PEROT RESIDENCE 141 BROOK ROAD			
GRADING PLAN			
		P.O. BOX 1085 WAITSFIELD, VT 05673 P: (802) 496-5130 F: (802) 496-5131 www.watershedca.com <i>*specializing in stormwater management and erosion-sediment control*</i>	
APPROVED BY:	AT	DRAWN BY:	SMS
DATE:	12-17-12.	CHECKED BY:	AT
SCALE:	NOTED		SHEET: 1 OF 1

From: Ross, Patrick [Patrick.Ross@state.vt.us]
Sent: Tuesday, June 18, 2013 15:40
To: Andres Torizzo
Cc: Pealer, Sacha; Kinny Perot; Miron Malboeuf
Subject: Re: Perot- 141 Brook Rd Warren

> **Subject: Perot- 141 Brook Rd Warren**

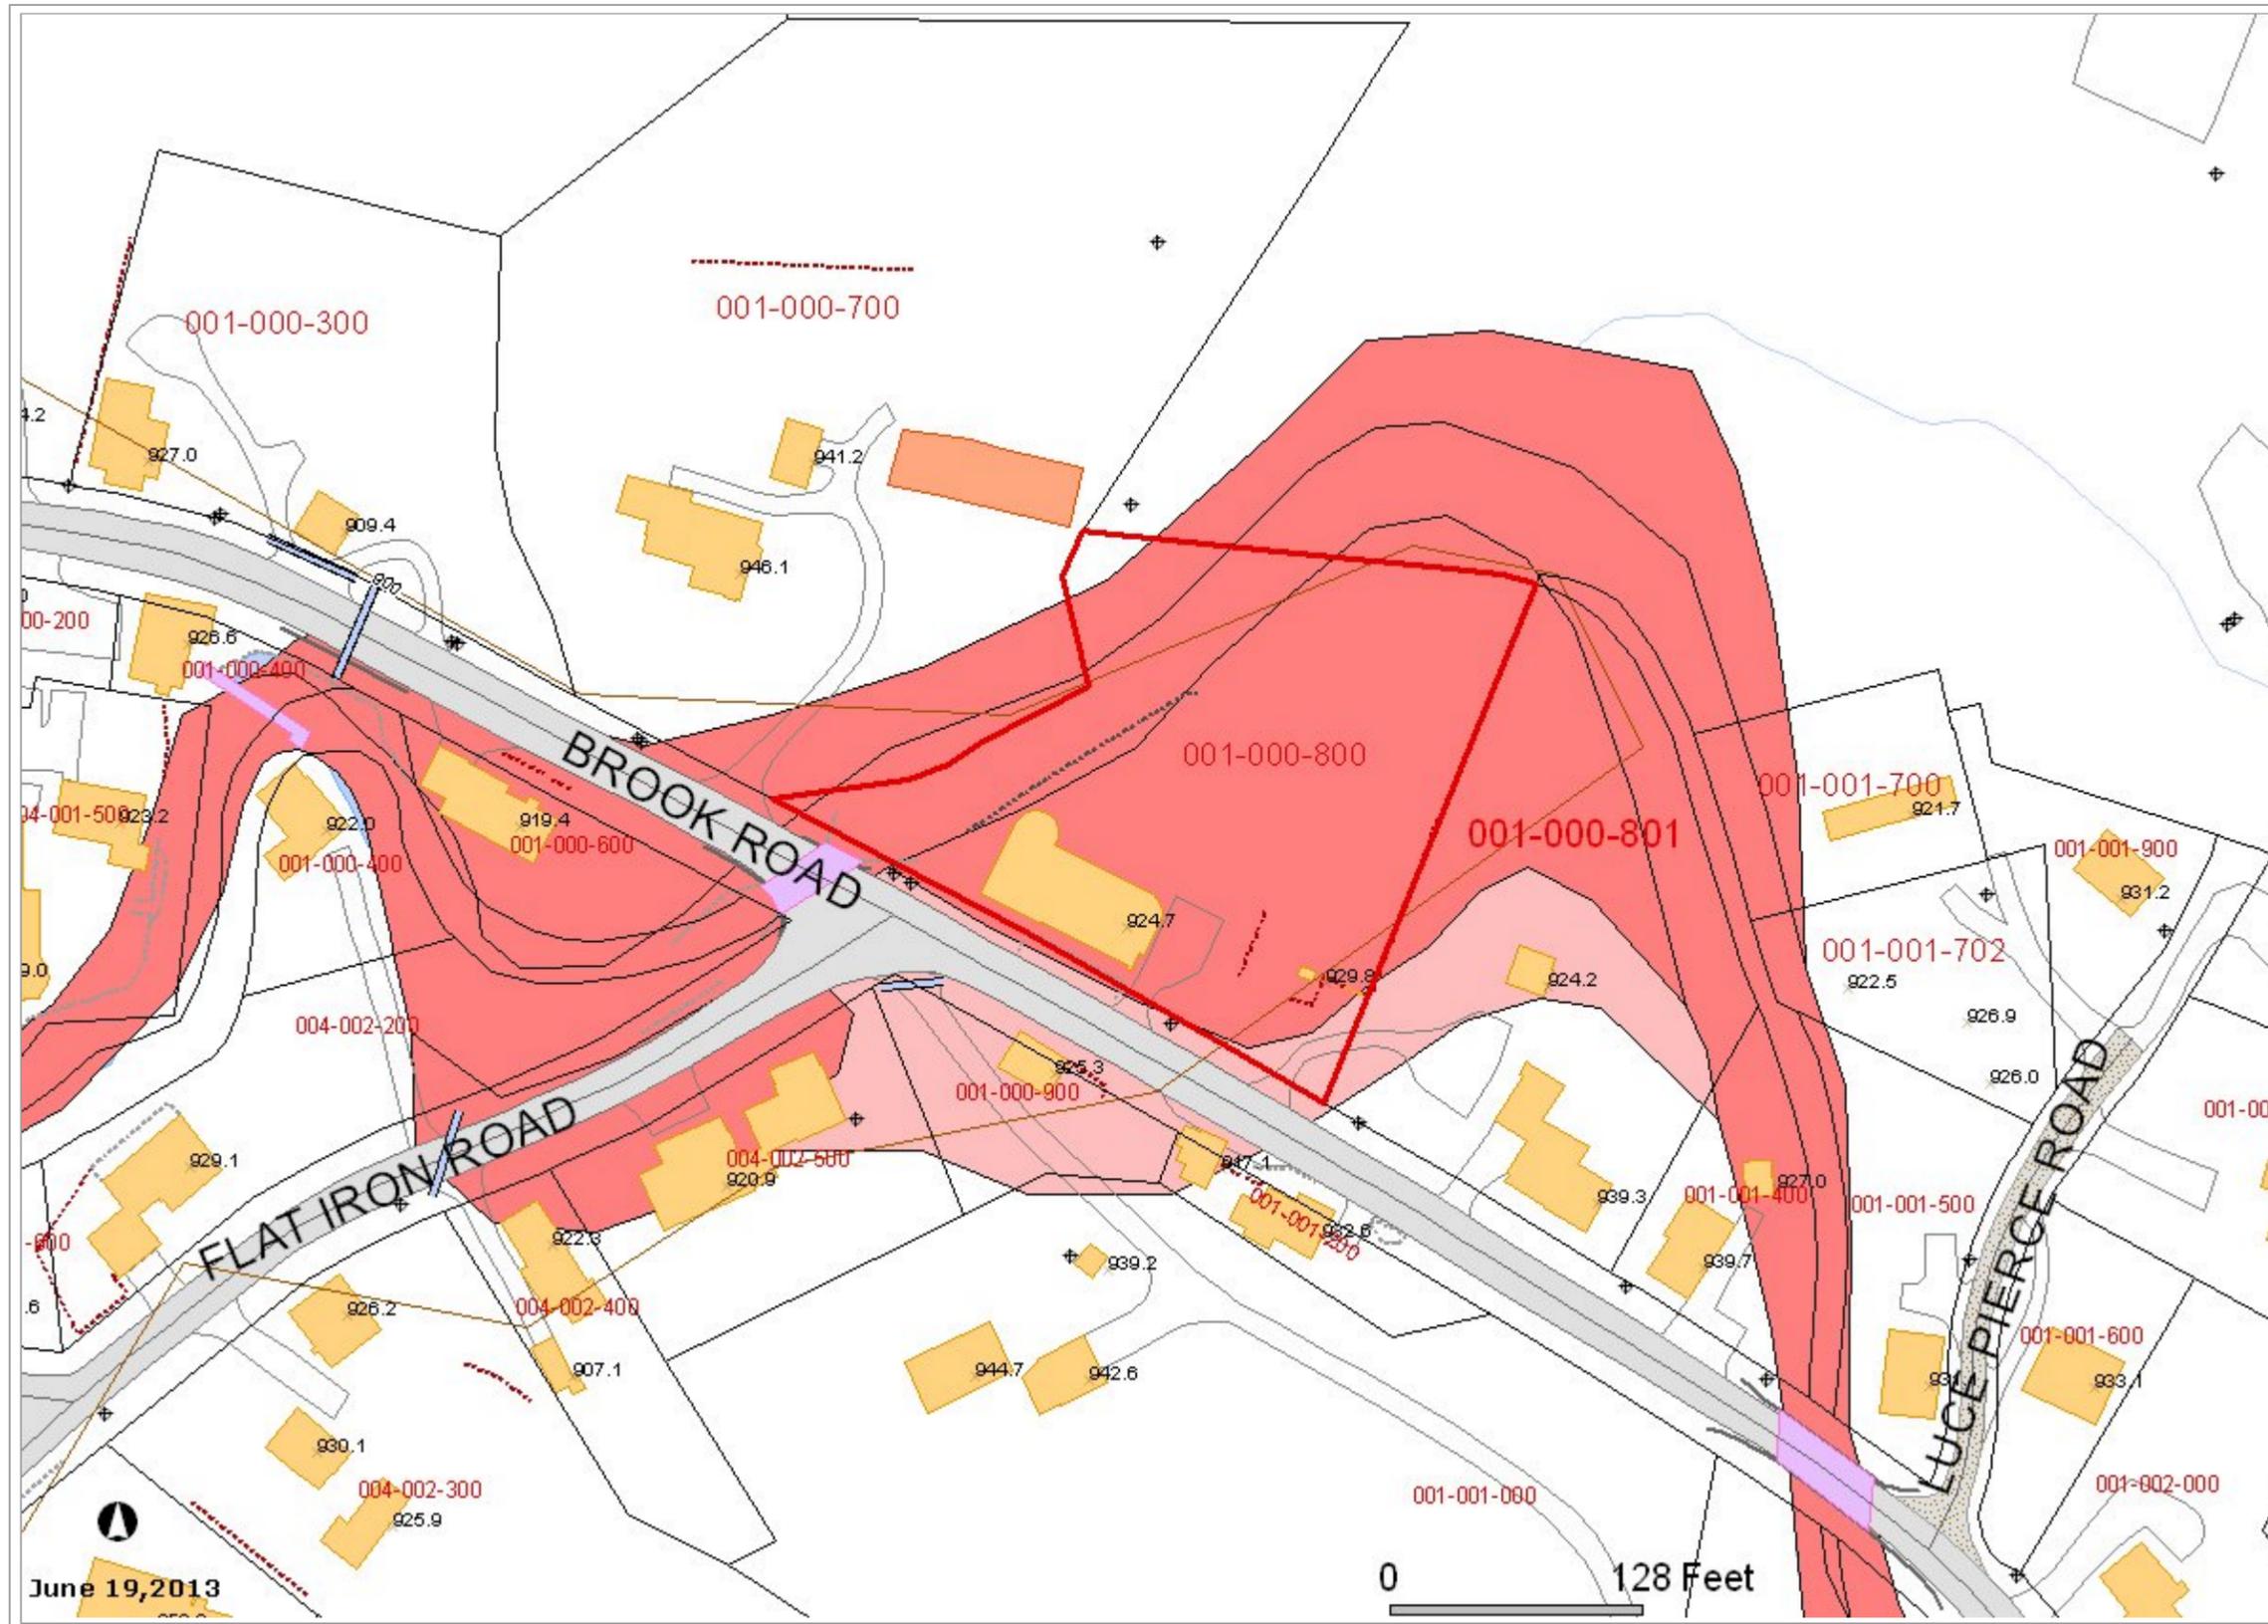
>
> Thanks for clarifying. Looks like the project as you've outlined would likely need a town permit because it is located in the FEMA floodplain (a.k.a. Special Flood Hazard Area) and because it meets the National Flood Insurance Program (NFIP) definition of development: "Any man-made change to improved or unimproved real estate, including but not limited to buildings or other structures, mining, dredging, filling, grading, paving, excavation or drilling operations or storage of equipment or materials." Because Warren participates in NFIP, the town regulates development in the floodplain. For town permitting, you would contact the zoning administrator, Miron Malboeuf (mmalboeuf@warrenvt.org<mailto:mmalboeuf@warrenvt.org>).

>
> I provide ANR floodplain review and comment on town permit applications, but I do not issue a state permit. The work you've described doesn't trigger concerns from my floodplain management perspective at this time, although you will need to document for the town records the fact that there

will be no net increase in fill, including the work to raise the driveway.

>
> Hello Andres,
> Can you confirm where the small berm will be? I am looking at your site plan, and the only possible proposed berm area I see appears to be directly to the east of the stone patio, running roughly in a north-south direction. Is this correct?

I agree, no issue.

> Thanks very much for the quick review of this. For clarification I attached an updated plan to this email. The plan demonstrates that there will be no net fill resulting from the project, including adding some surface material on the driveway.

> Exactly. It would parallel the new swale directly to the east highlighted in blue. If you look closely you can see the word BERM near the road.
